ORDINANCE NO. L-2016-5
VILLAGE OF SHOREWOOD HILLS
DANE COUNTY, WISCONSIN

AN ORDINANCE CHANGING THE ZONING CLASSIFICATION OF PROPERTY
LOCATED AT 2801-2725 MARSHALL COURT
FROM C-3 MEDICAL OFFICE-COMMERCIAL DISTRICT
TO A PLANNED UNIT DEVELOPMENT (PUD) DISTRICT

Re: Review of the proposed rezoning of 2725-2801 Marshall Court: "Arbor Crossing II"
From: Medical Office-Commercial (C-3)
To: Planned Unit Development (PUD) / General Development Plan (GDP)

C-1.0

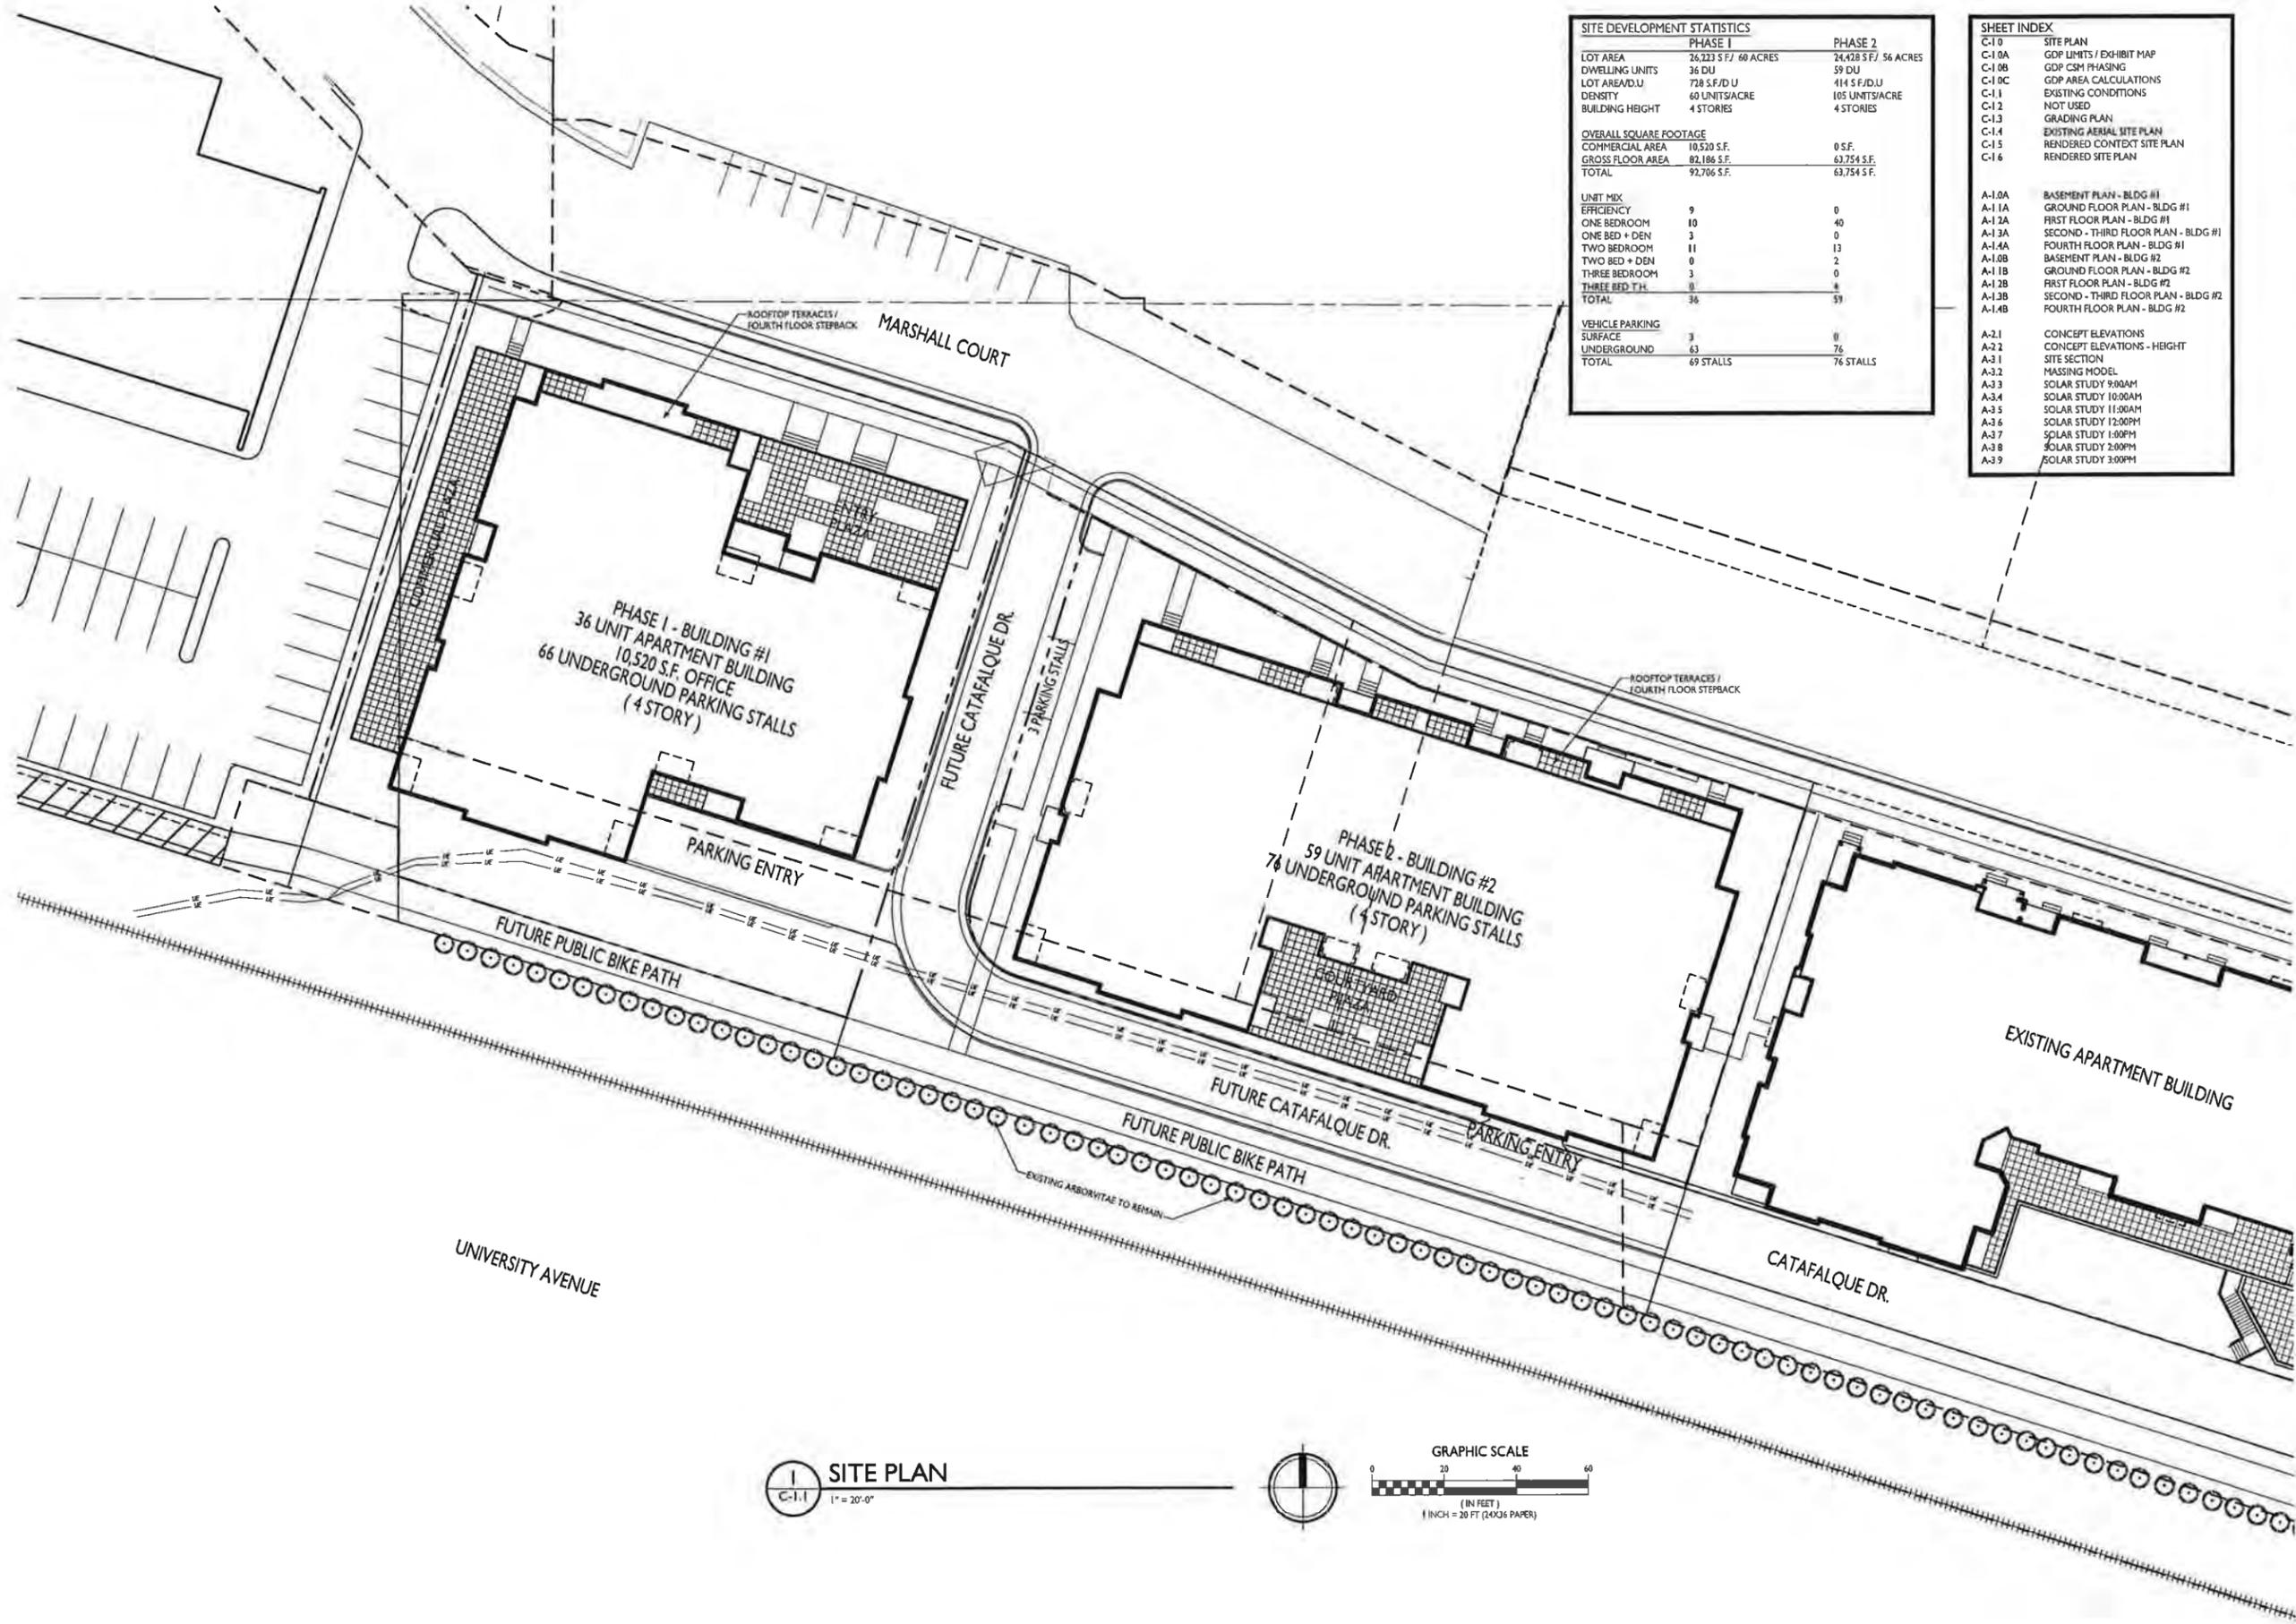
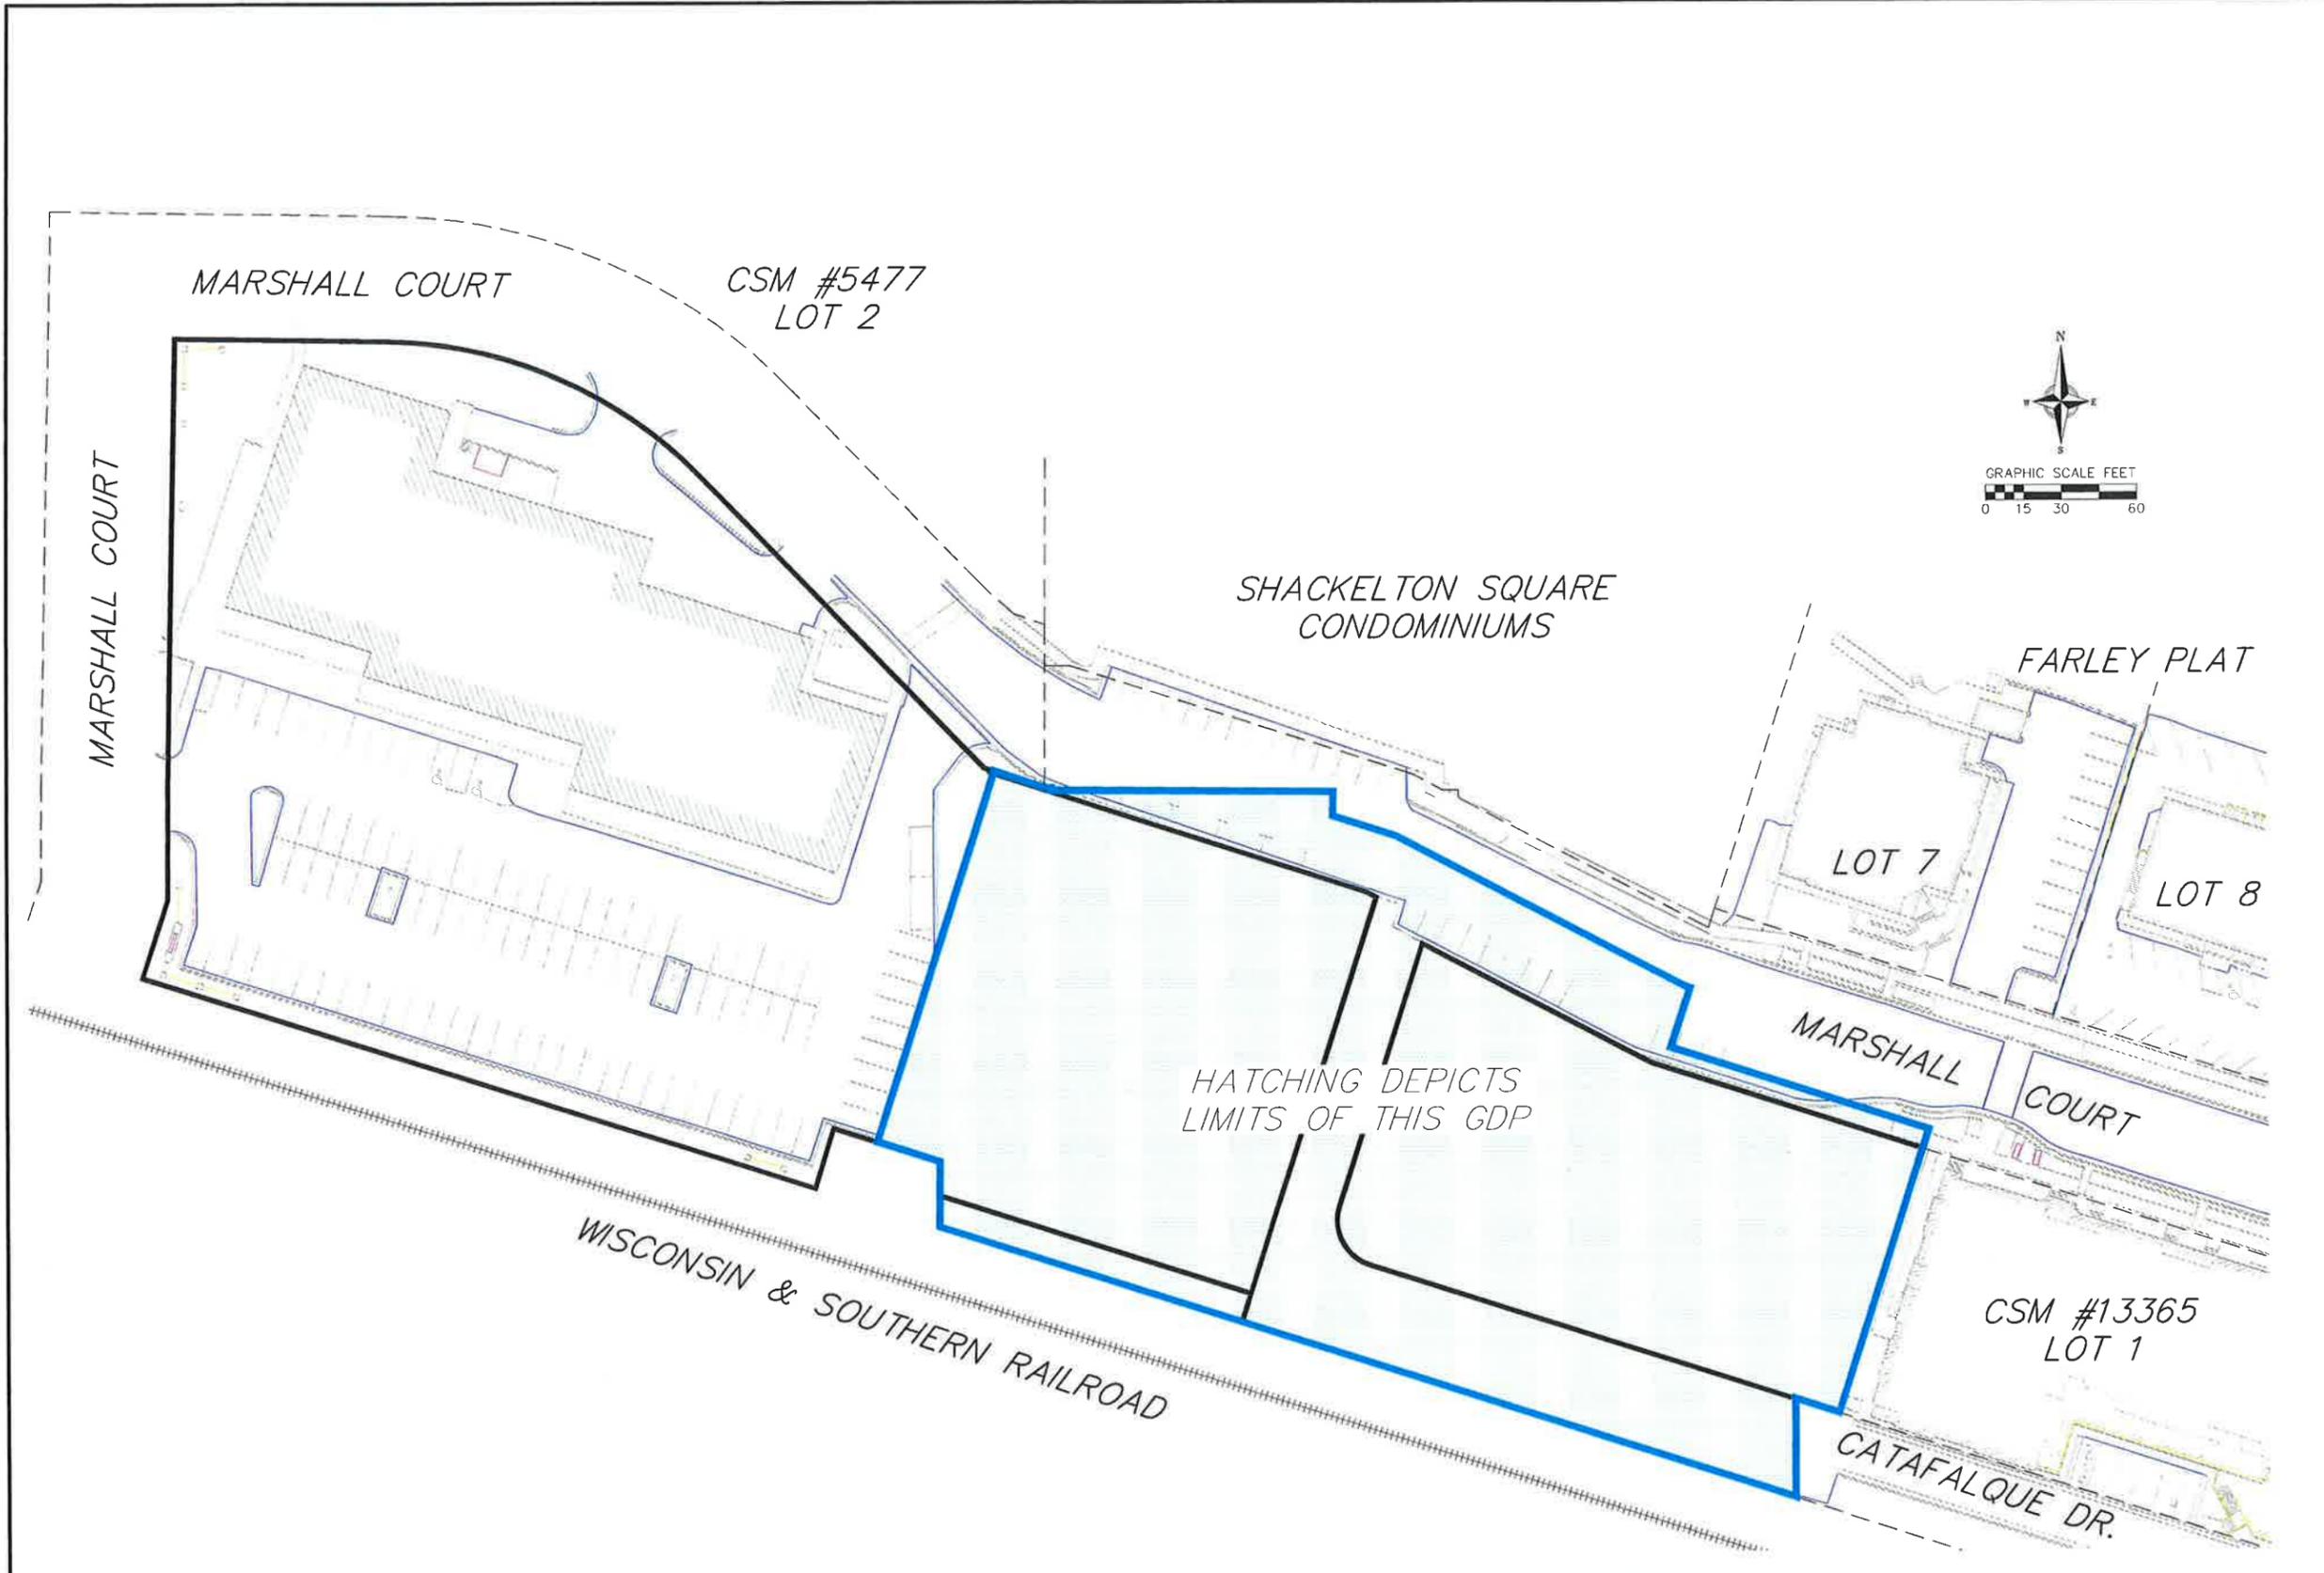
- Sheet C-1.0: Site Plan depicting the proposed development in plan view.
- Sheet C-1.0A: GDP Limits Exhibit Map depicting the boundaries of the GDP.
- Sheet C-1.0B: GDP CSM Phasing & Right-of-Way Configuration Map showing the boundaries of Phase 1 and Phase 2, and the areas proposed for street and bike path dedication.

A-2.1

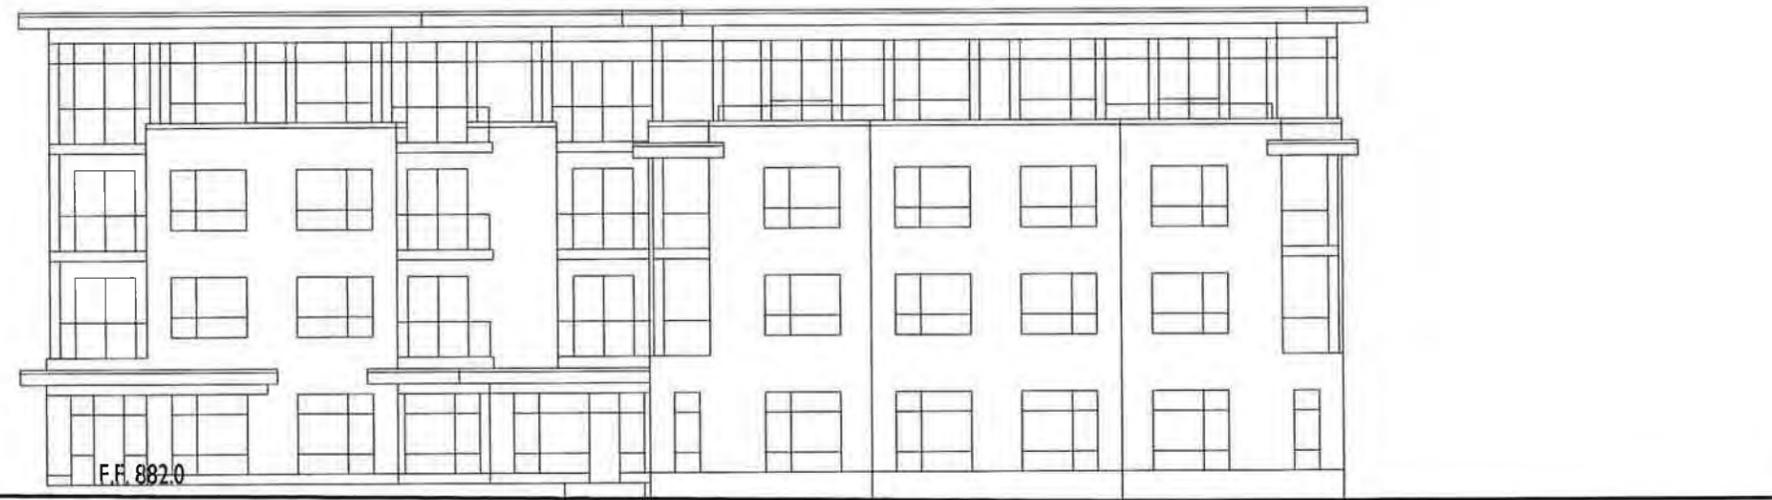
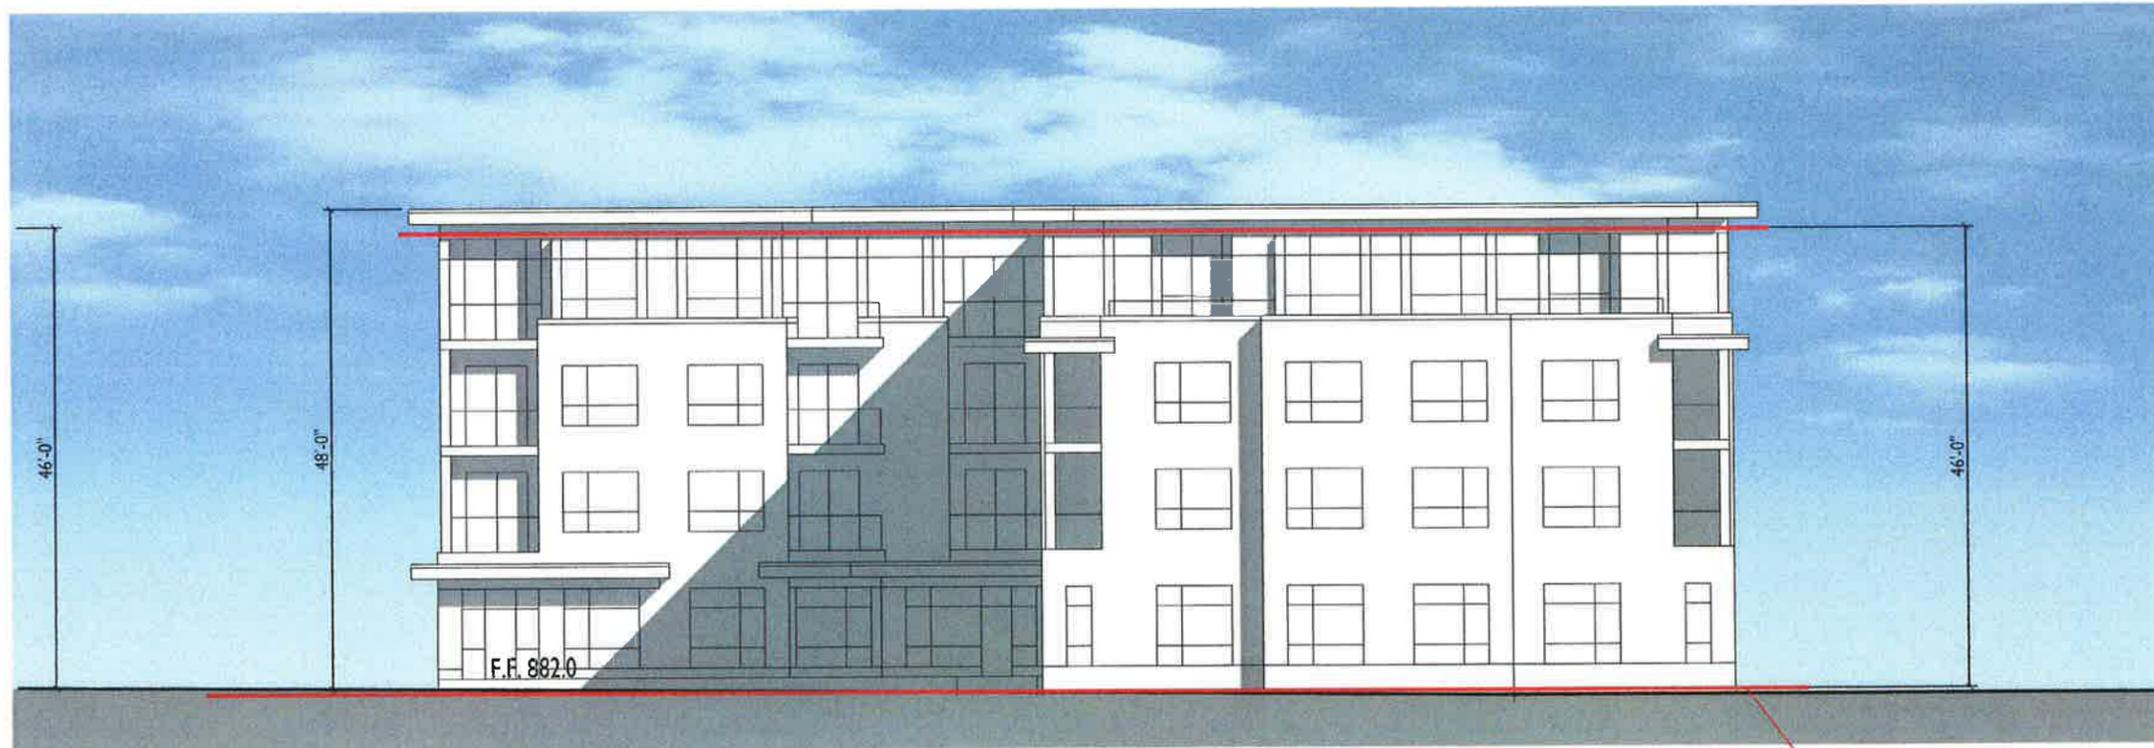
The top floor of both buildings has a step-back on the north façade to reduce shadowing onto the north side of Marshall Court. The western building shows a six- to eight-foot step-back, with a six-foot step-back shown for the eastern building. The building height to the top of the roof eaves are 48' 0" on Building 1 and 48' 9" on Building 2 – compared to the maximum of 46 feet set by the Doctors Park Neighborhood Plan. The detailed winter solstice shadow study provided in the submittal indicates late afternoon shadowing of the ground floor of the Ronald McDonald House and Shakleton Square, originating from the western building.
